ADDENDUM No. 2

| REQUEST FOR QUOTATIONS (RFQ) No.: TITLE: | 1220-040-2020-055 Outdoor Pool Drainage Upgrades |

See attached revisions to civil scope to Holly Pool from the Consultant.

| | THE C & MA THAN THE L APPR OWNE EXAC AGREI BE OC PRESE | RTIN CONSUL THAT AUTHO OCATION OF DXIMATE WAN R OR ITS RE I LOCATION O ES TO BE FU DCCASIONED B | TO ALL DESIN TANTS LTD. DRIZED BY A EXISTING UN Y ONLY & H, PRESENTATIV OF ALL EXIS ULLY RESPON Y THE CONT | GNS AND DRA REPRODUCTIC PLIN & MARTI NDERGROUND AVE NOT BEEI Æ. THE CONTI TING UTILITIES SIBLE FOR AN | WINGS ARE TH N OR USE FO N CONSULTAN UTILITIES ARE N INDEPENDEN RACTOR SHALL BEFORE COM IY AND ALL D LURE TO EXAN LITTES. | OR ANY PUF NTS LTD. IS NTLY VERIFIE L DETERMIN IMENCING W DAMAGES WI | RPOSE OTHER PROHIBITED. ED BY THE IE THE /ORK, AND HICH MIGHT |
|--|---|--|--|--|--|---|--|
| IS THE RESPONSIBILITY OF THE CONTRACTOR'S SURVEYOR TO VERIFY THAT ALL LEGAL SURVEY DIMENSIONS SHOWN ON THE ENGINEERS DRAWINGS AGREE WITH THOSE ON THE REGISTERED LEGAL SURVEY PLAN. SHOULD THERE BE ANY DISCREPANCIES, THEN IMMEDIATELY NOTIFY THE ENGINEER OF RECORD | APPR RSL | OVED | | | C03 | | 5 |

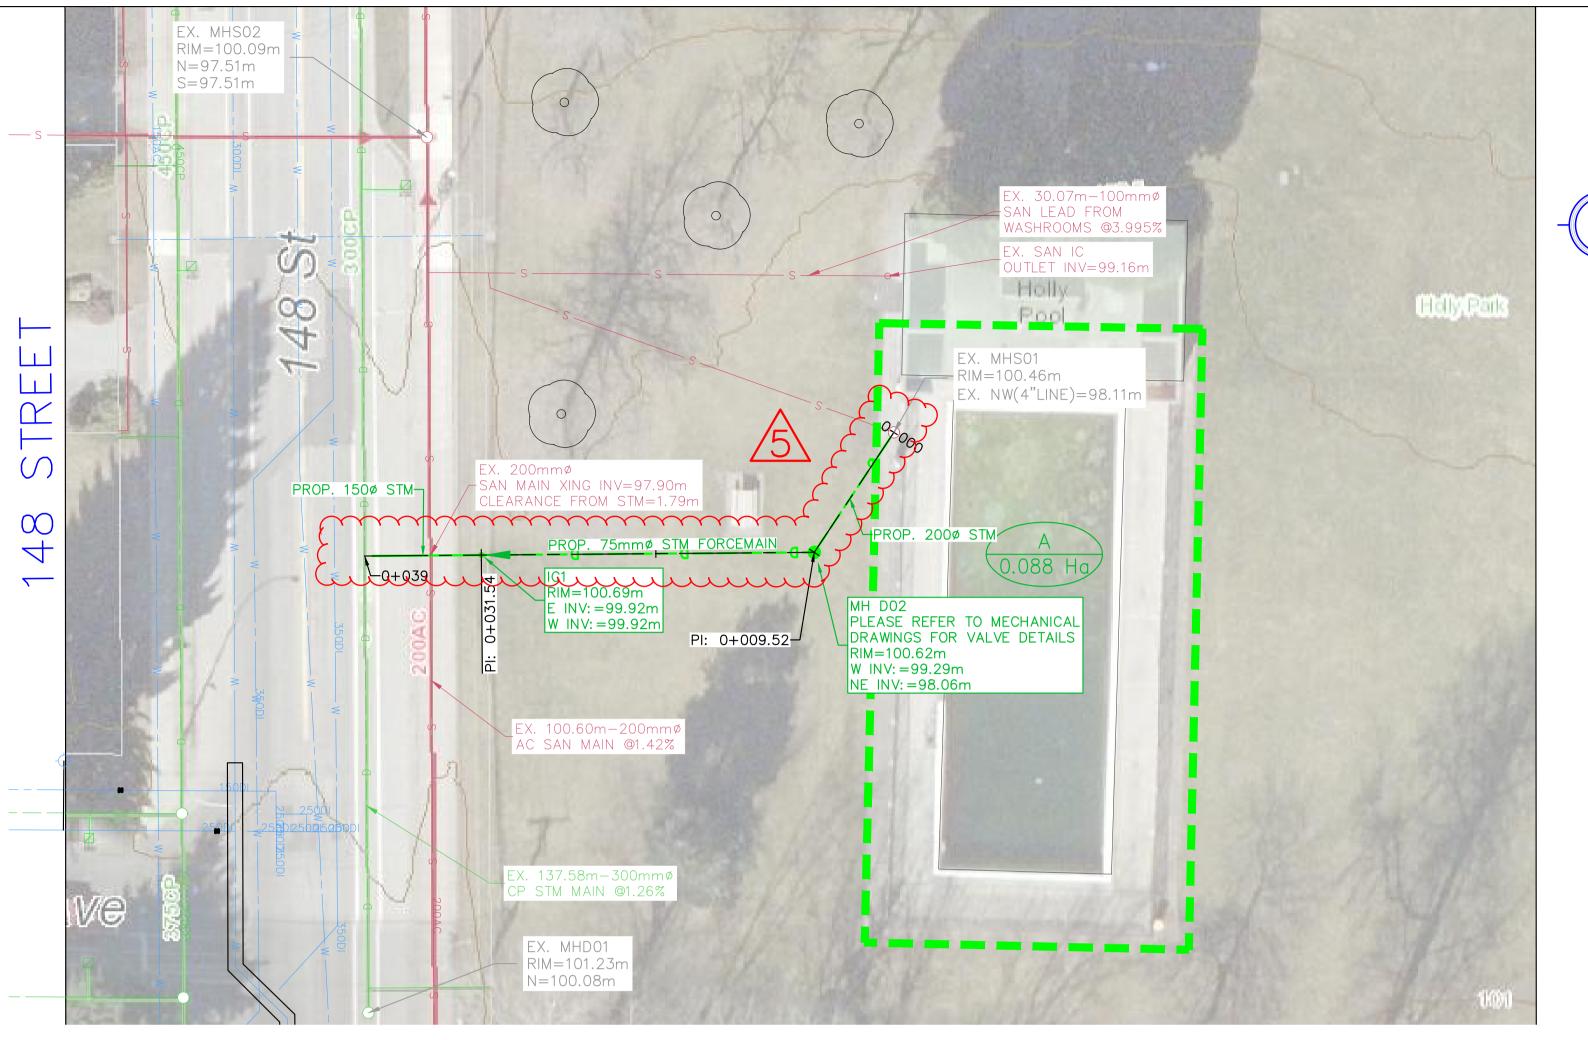
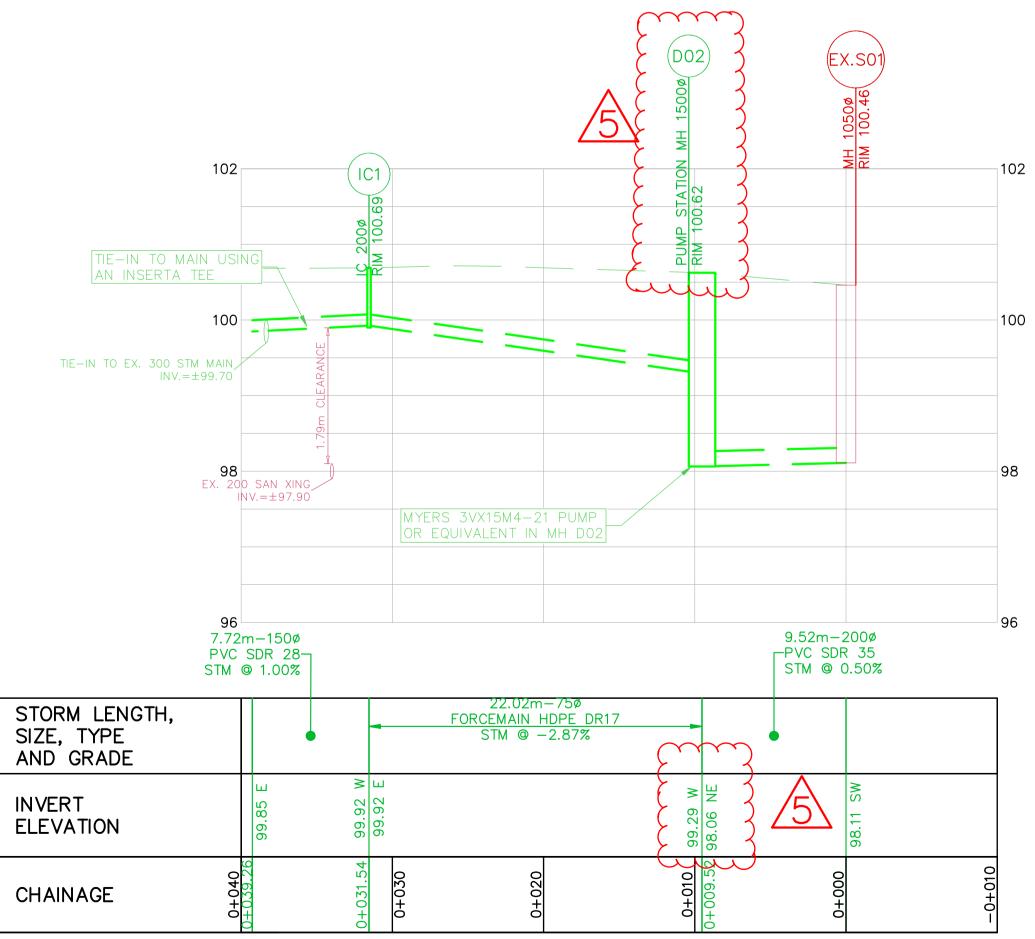
- 1. CIVIL Drawing 19-5003-CO3: New proposed storm main alignment to avoid existing onsite trees by moving south of the existing park bench. Location of manhole DO2 has changed. See drawing CO3 Rev. 05 (05/10/2020) Issued for Tender, Addendum #1.
- CIVIL Drawing 19-5003-C03A: Pump Station modified to incorporate a rail guide system for lifting the pump, a 3-float alarm sensor system, EYS seal moved above the junction box, & Tie-In of the high-level alarm to the existing onsite security system. See drawing C03A Rev. 05 (05/10/2020) Issued for Tender, Addendum #1.
